STORE PROPERTY INVESTMENTS LTD
LAND WEST OF BROOK LANE AND
SOUTH OF A259
RUSTINGTON

ROAD SAFETY AUDIT RESPONSE
REPORT
STAGE 1 - ROAD SAFETY AUDIT

JUNE 2018

Project Code:	SPRust(BrookLane).1.
Prepared by:	OAN
Approved by:	VL
Issue Date:	June 2018
Status:	Final

drawing number SPRUST(BROOK LANE).1/10 rev. B

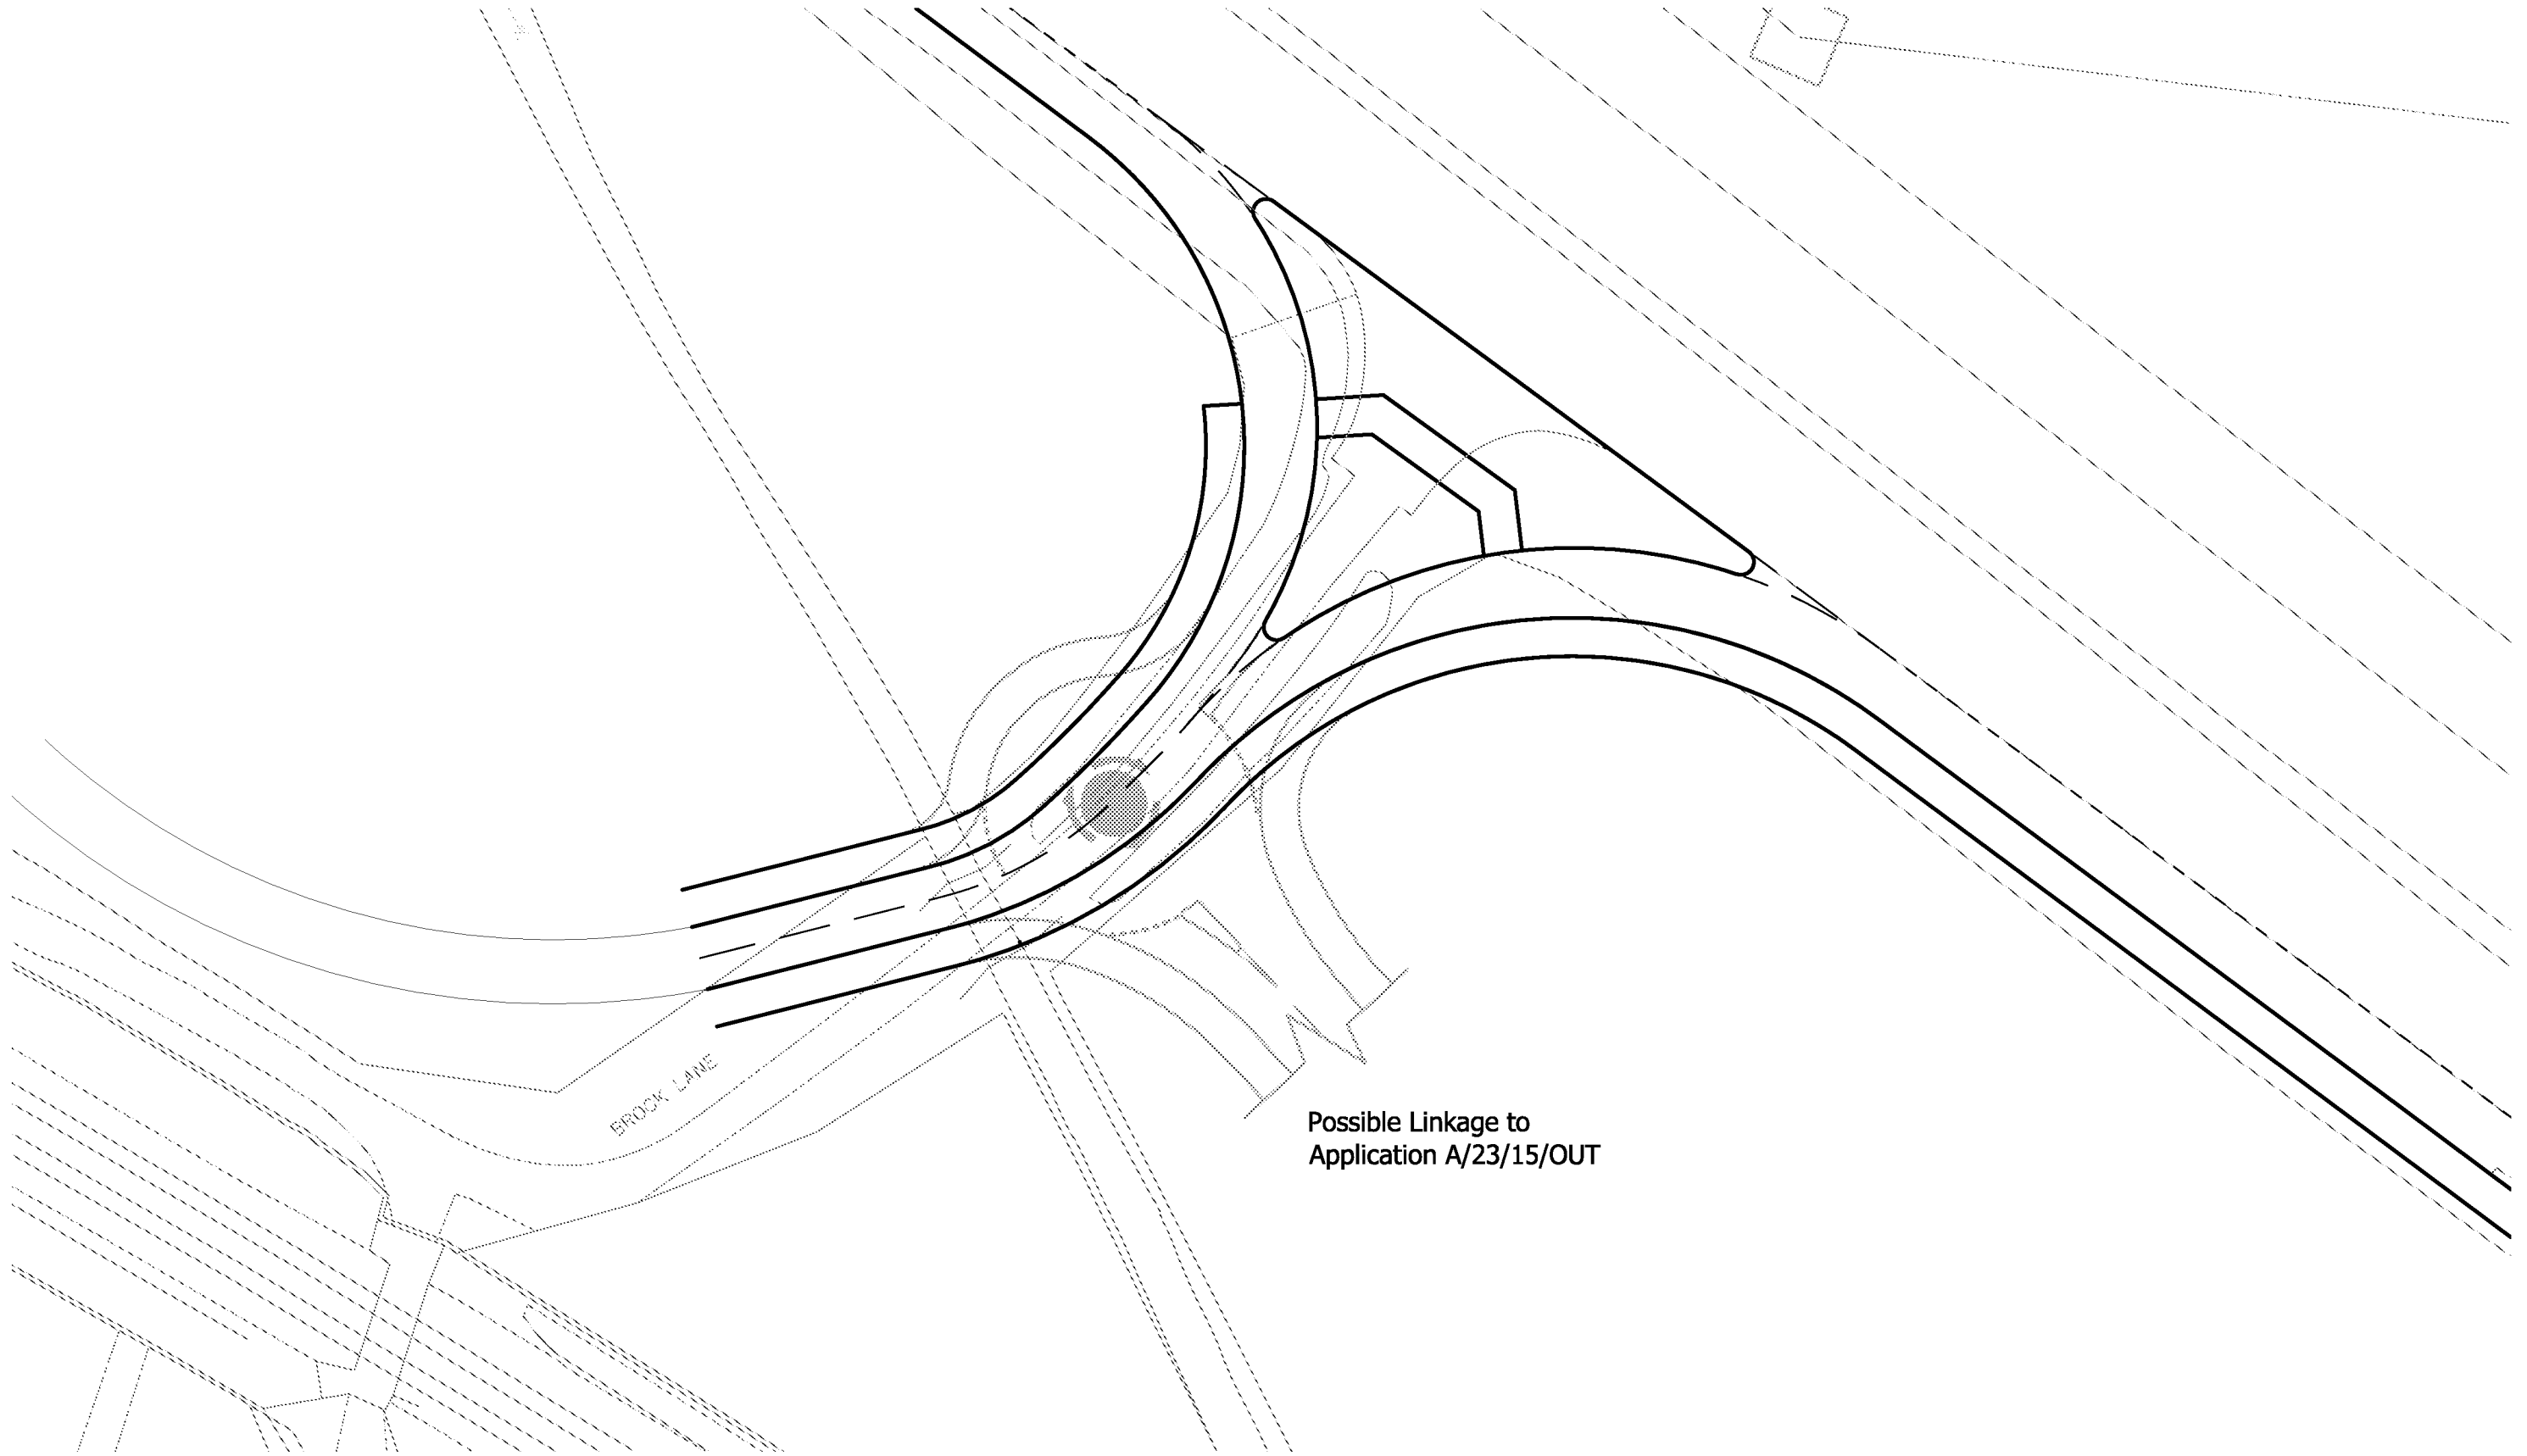
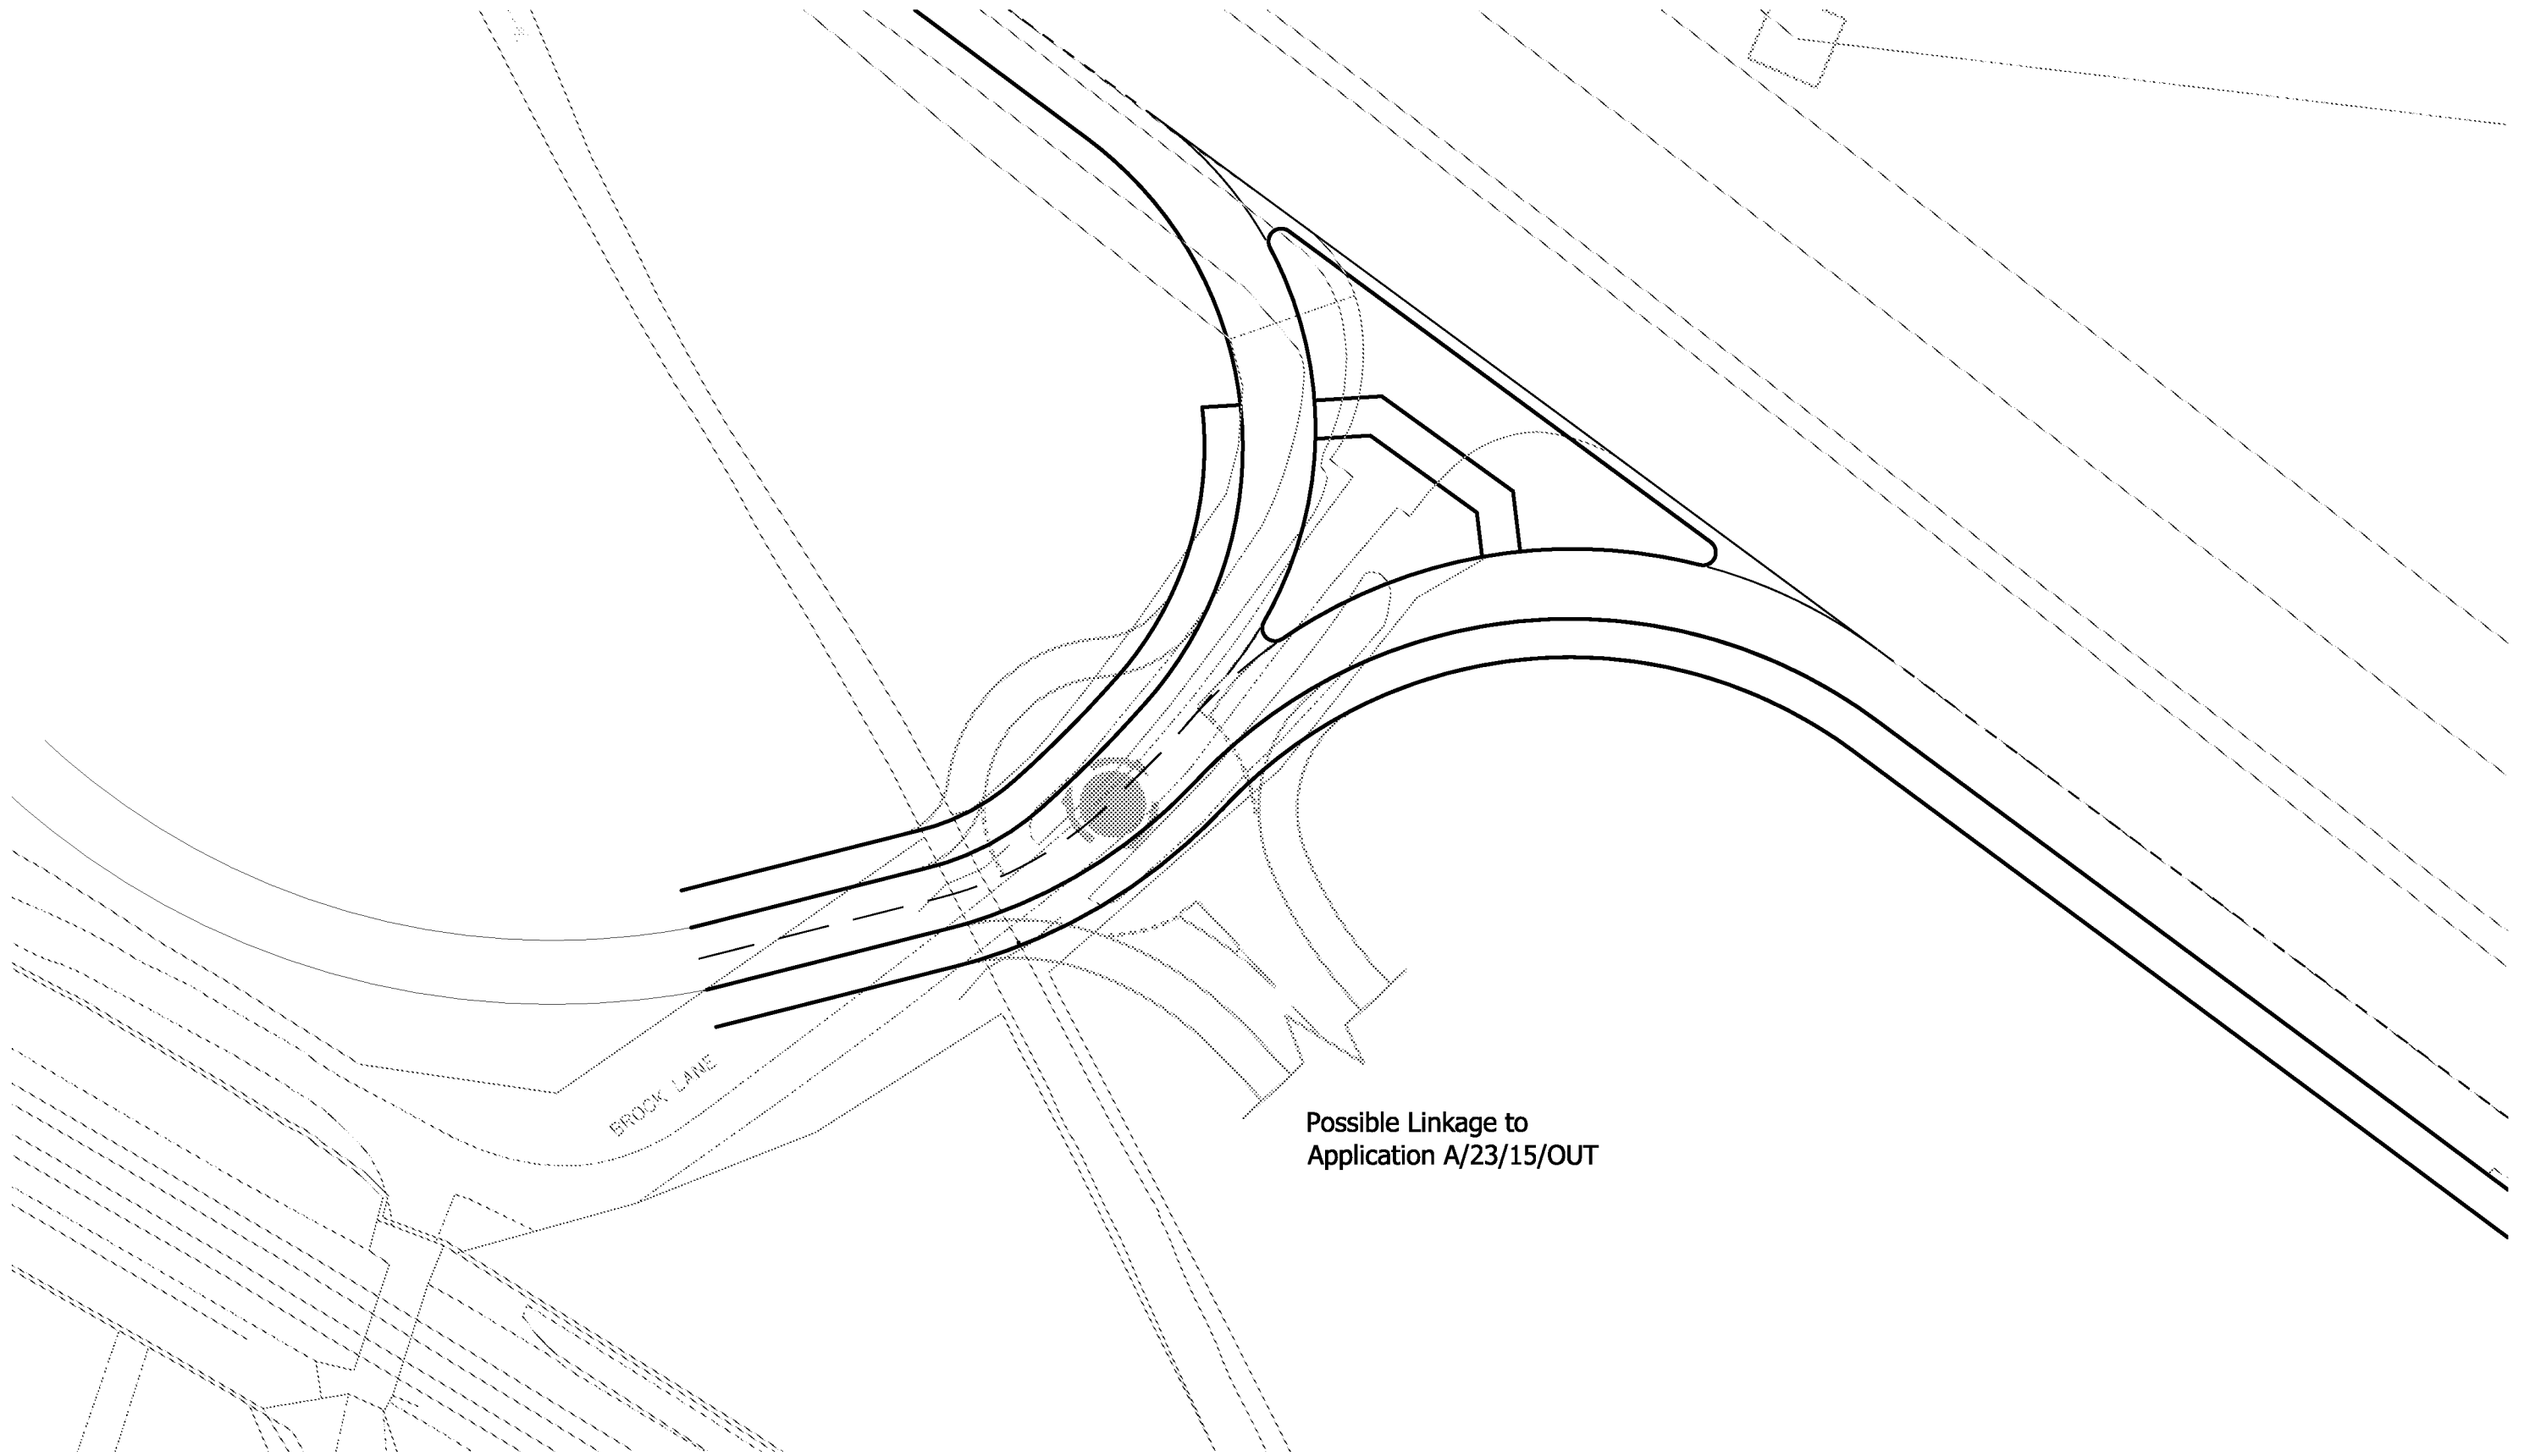
Location: Proposed central island

Summary: Margin omitted

The westbound approach on the A259 to the proposed junction is provided with a margin (circa 1 metre), is delineated by a solid white line. The proposed northern kerb line of the proposed traffic island does not benefit from a margin. This could result in vehicles striking the kerb and subsequently losing control.

Offset the northern kerb line southwards to provide an appropriate margin.

This is agreed, drawing SPRUST(BROOKLANE).1/10B included at **Appendix D** shows a revised kerb line to include a 1m margin.
